Document ID 1334122	Version 1.0	Status Approved	Reg no	Page 1 (7)
Author Allan Hedin			Date 2012-02-13	
Reviewed by Olle Olsson			Reviewed date 2012-02-15	
Approved by Helene Åhsberg			Approved date 2012-02-16

SKB's response to additional question from the NEA IRT

In an e-mail forwarded from SSM, dated 3 February 2012, the NEA IRT has put the following, final question to SKB as part of the on-going review of the safety assessment SR-Site:

Figure 2. Summary of far-field mean annual effective dose for probabilistic calculations for the corrosion scenario. The peak doses are given in parentheses in µSv.

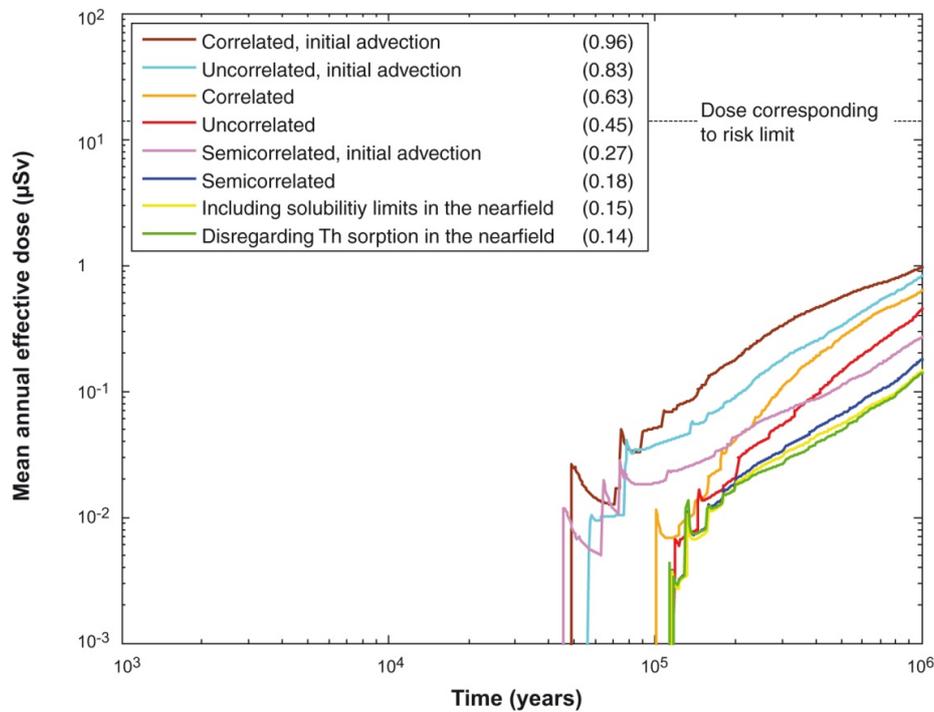
“Given the conservative assumptions and data SKB uses in its assessment of the performance of the proposed repository, please describe if and in what manner those conservative assumptions bias the repository system understanding and the results of the SKB performance analyses. For example, if a “best estimate” set of assumptions and data were used, would there be a difference in the dominant radionuclide(s) contributing to dose, or the relative importance of various “barriers” (e.g. bentonite buffer, bentonite backfill, copper canister, spent fuel dissolution rate, radionuclide transport through the backfill and geosphere, biosphere dose conversion factors)?”

As seen in the figure, the semi-correlated base case (the dark blue curve) yields a dose that is less than an order of magnitude below the pessimistic compliance case, i.e. the correlated case with initial advection (the brown curve). Assumptions underlying the transport cases are discussed in the following.

- Generally, the input data to the transport calculations are given as probability distributions established in the SR-Site Data report. These have been cautiously selected according to established procedures, but cannot be characterised as particularly pessimistic and should hence not bias the system understanding.
